Wentworthville Public School (SSD 9273): Submission of Design Modifications in accordance with Condition B1 & B2

Wentworthville Public School (SSD 9273): Submission of Design Modifications of Block G at Intersection of Fullagar Road and Station Street.

Wentworthville Public School SSDA Condition B1 – Design Response

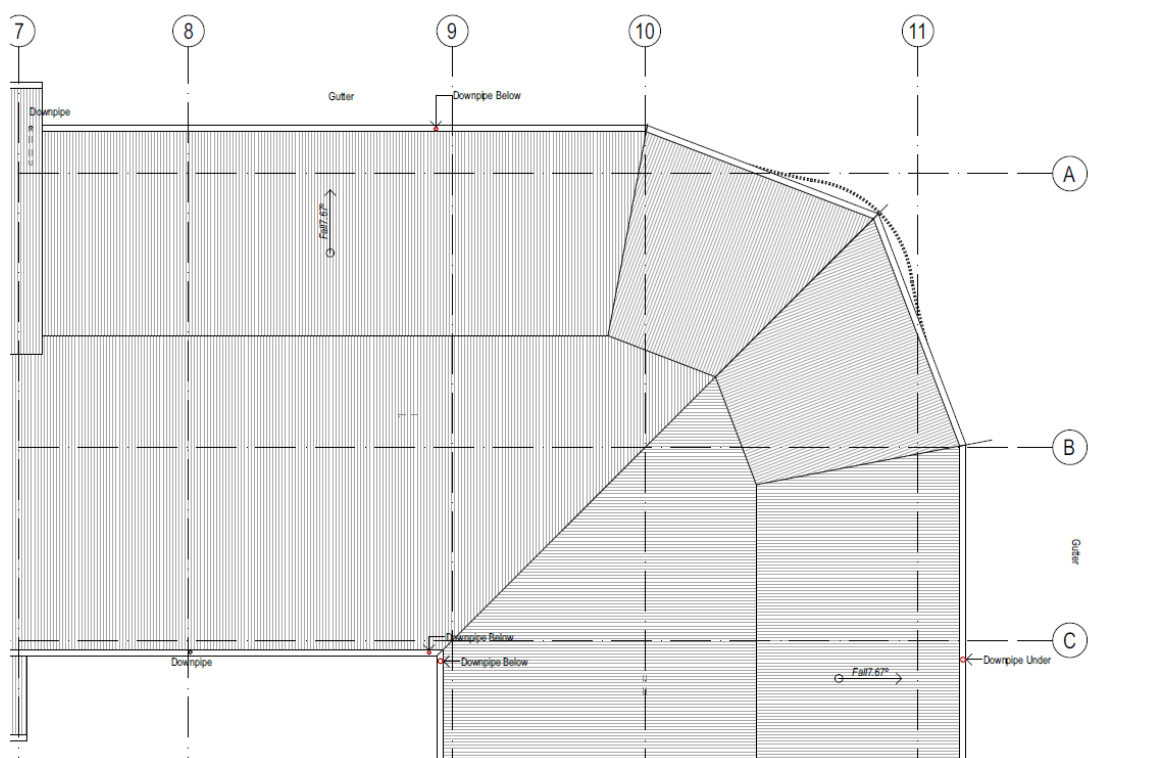
- Roof Redesign –

It is proposed that the roof is to be redesigned to remove the large skillion roof and generous overhang to the corner of the site. Instead the roof is modified to be a continuation of the roofs over the Northern and South-Eastern wings of the building. The pitched roof steps around the corner and falls to gutters on both sides of the building – rather than just to the verandah side. This reduces the overall height and mass of the building as it addresses the corner.

A sketch of the proposed roof is shown below as well as in Appendix A –

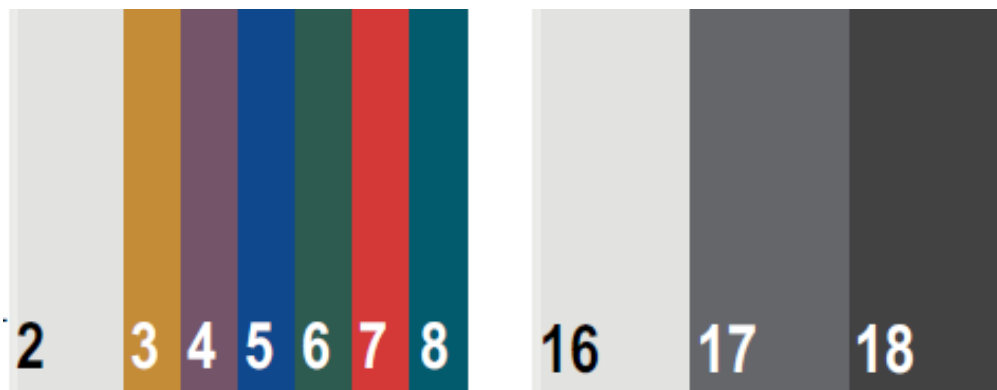
- Screen Redesign

The original design included a 'feature screen' to the curved corner of the building. This screen featured a pattern and stood in contrast to the vertical aluminium batten screens that run over the Northern and Eastern faces of the building. It is proposed that this 'feature screen' will be deleted and replaced with a screen similar in design to the vertical aluminium batten screens to the remainder of the building.

An image of the preliminary re-design of this screen is shown below and in Appendix B –

This new screen will tie into the existing screens to the other parts of the building, but will be modified in a number of ways to create a feature at the corner of the building and in order to layer over the building behind. This approach will mean that the corner screen will reflect the screening provided around the Covered Learning Areas to the South-Eastern corner of Building G – as shown below. This strategy will mean that the corner area is integrated into the overall design to a greater degree.

The details and layout of the screen will need to be refined further. In doing this it is intended to achieve the following –

- o The screen will curve and step out around the Withdrawal spaces located on the corner so that they sit behind the screen rather than stepping through the screen to create a glass box as they did in the original design.

- o The vertical height of the screen will extend higher and lower than the screens to the other parts of the building. This will allow the screen to extend in front of the eaves gutters of the roof as well as creating a feature for the building at the corner of Fullagar Road and Station Street – a prominent corner within Wentworthville.

- o The detailing of the screen will feature cut out areas (shown roughly in the image above). This will allow greater views from particular parts of the building (particularly the Withdrawal Spaces) as well breaking down the scale of the screening in this area of the building. This will also add to the 'feature' that the screen is intended to create at the corner.

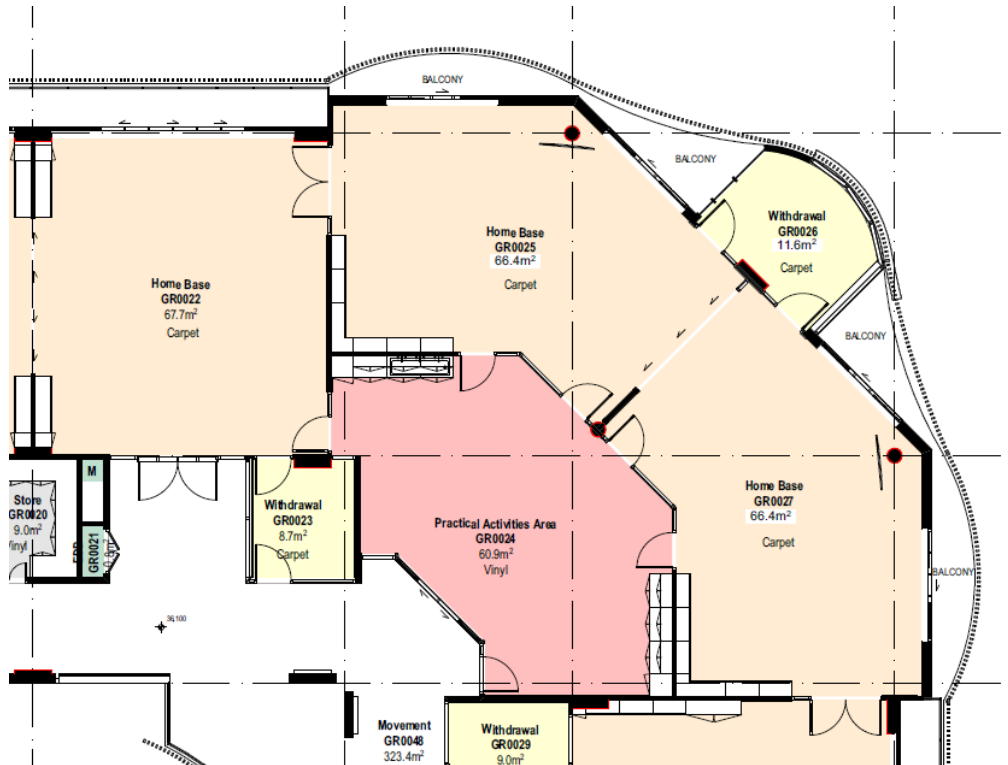
- Revised Planning -

The teaching spaces and withdrawal spaces to the corner of the building will be re-designed to remove the curved walls that previously existed to the corner. This means that the roof over these spaces can be simplified and removes the need for any curved gutters or fascias.

This revised planning will retain the exact areas of the internal, functional spaces. It is intended that the balcony spaces will also be managed to ensure they match the existing areas or are slightly reduced.

The proposed revised planning is shown below as well as in Appendix A.

BUILDING G CORNER RE-DESIGN - ROOF PLAN

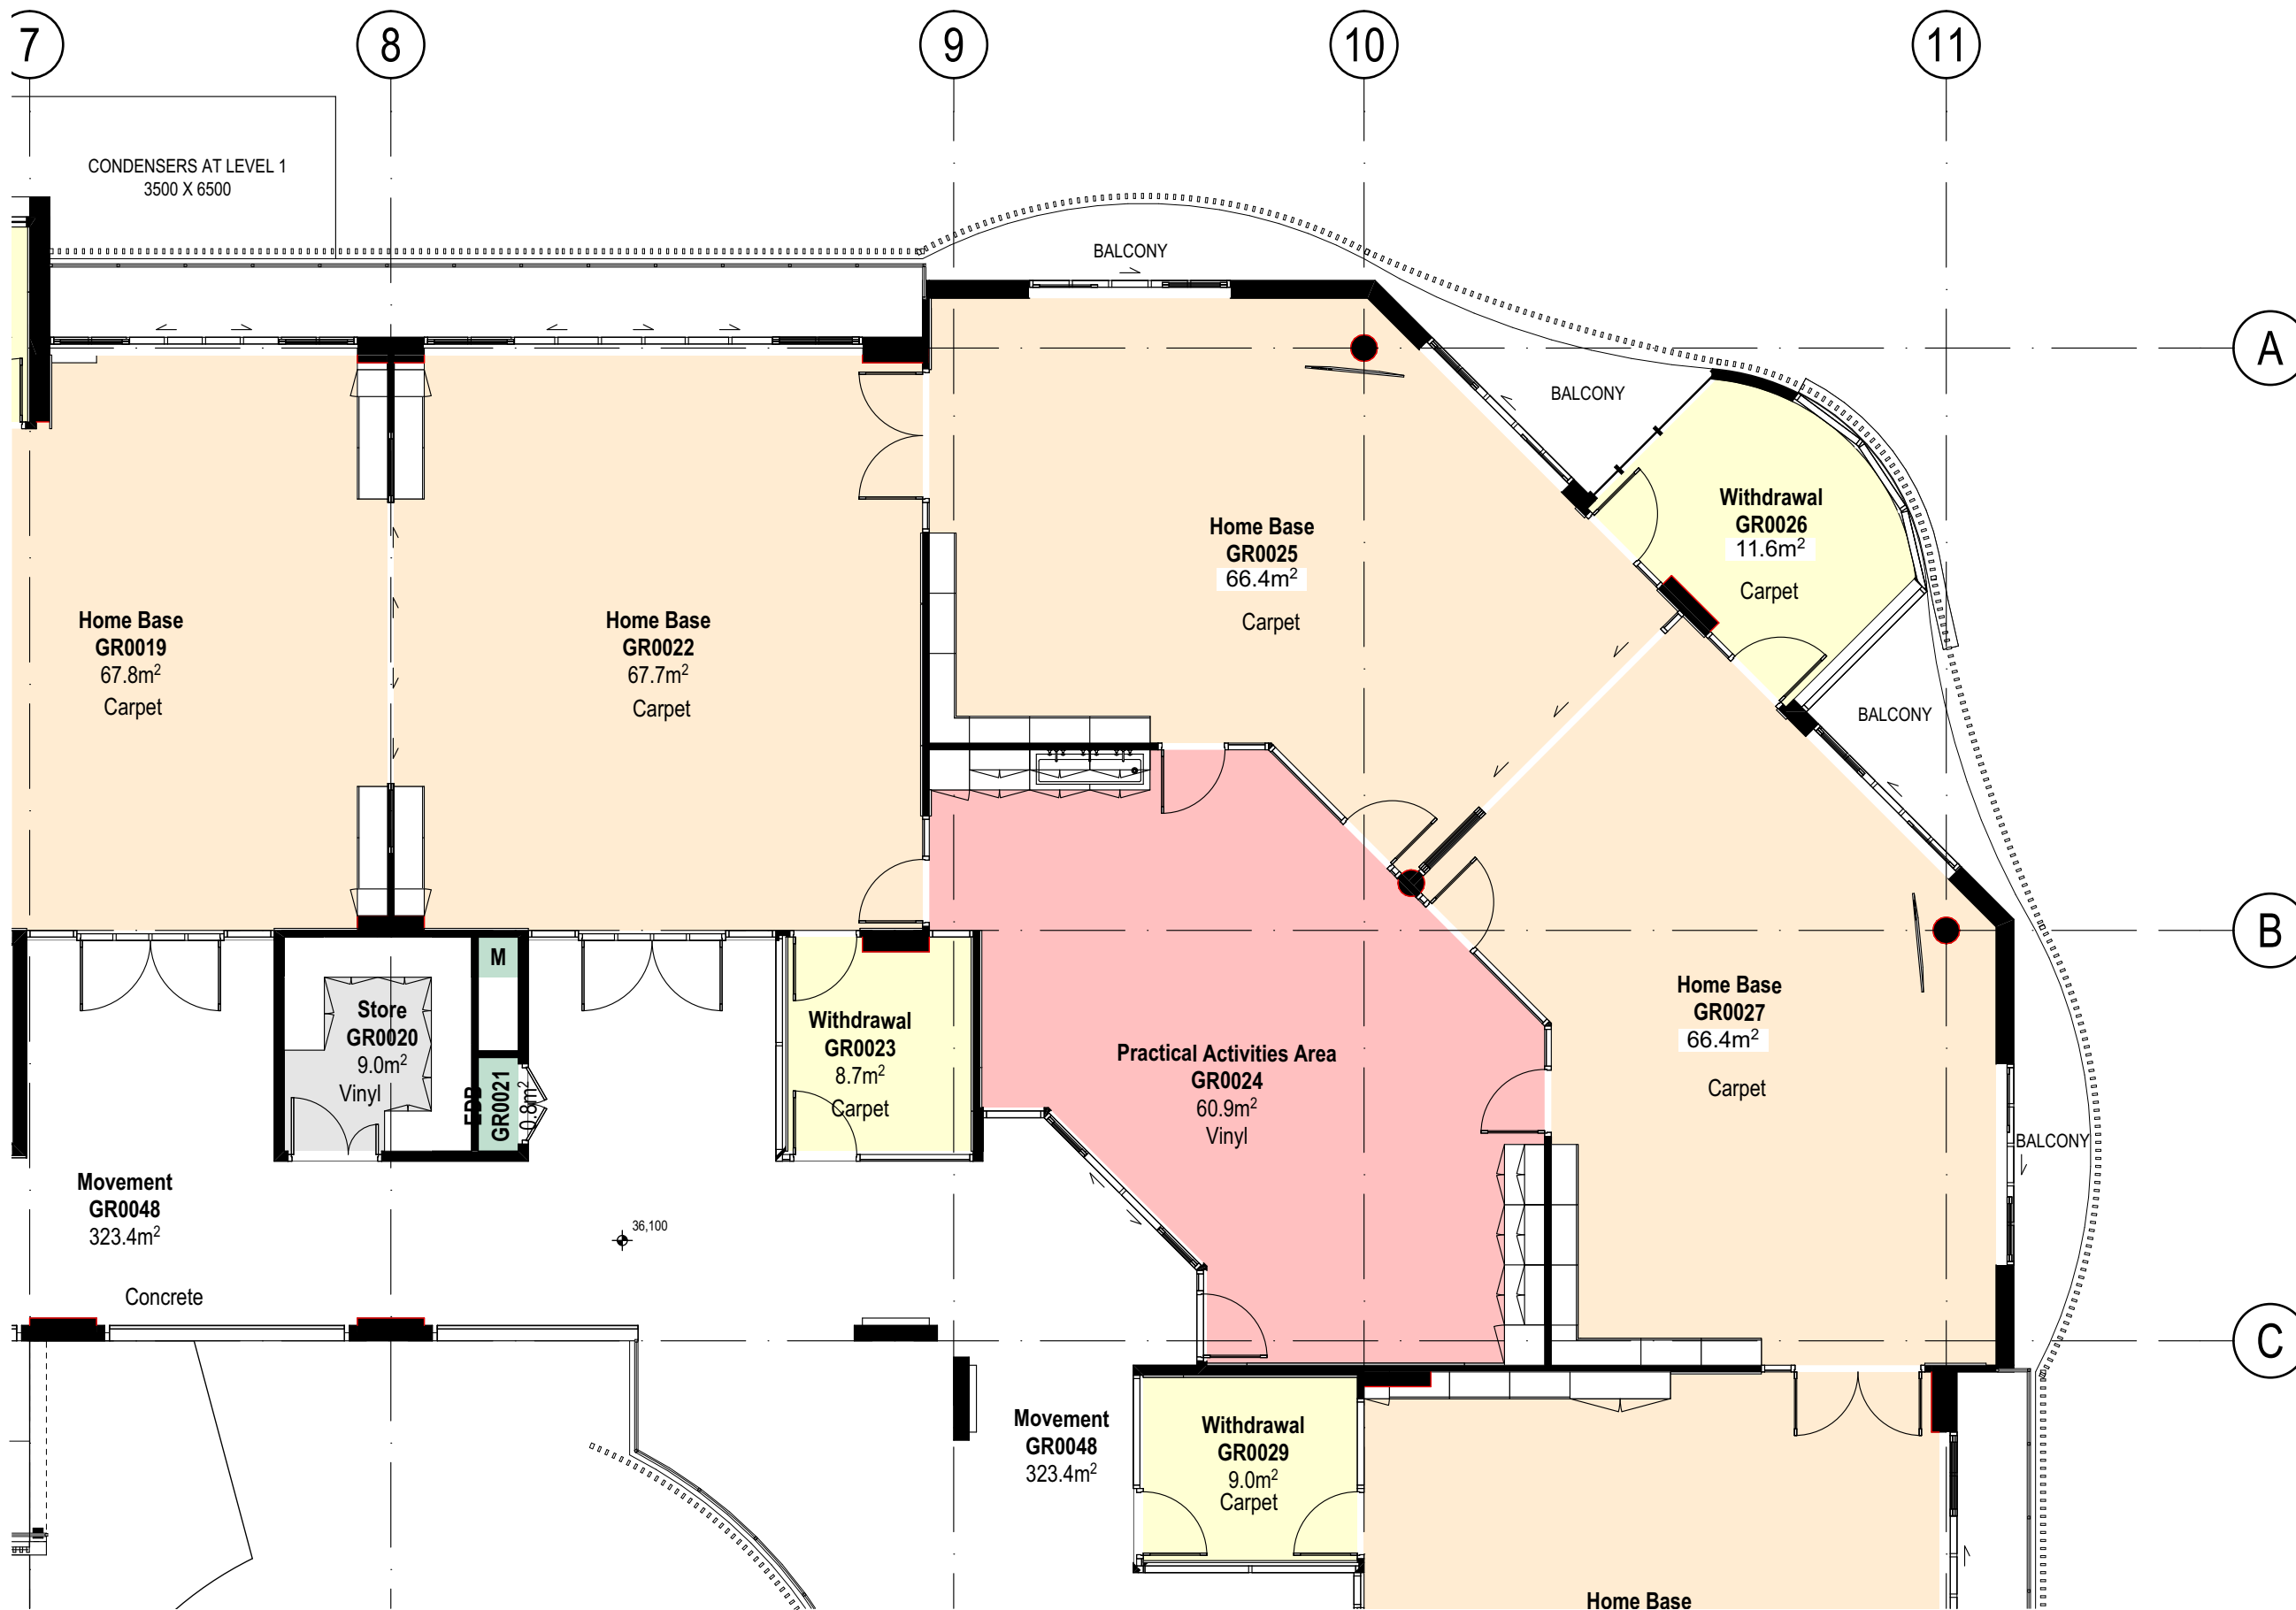
The response to this condition will be consistent with the response provided to condition B1 – as outlined above. This response addresses the planning materials and colour palette of the revised design.

Once approval has been received for the proposed revisions to the design a set of documents will be produced to fully detail the revised design. This will be accompanied by a revised version of this Design Statement to provide a narrative of the final proposed design response.
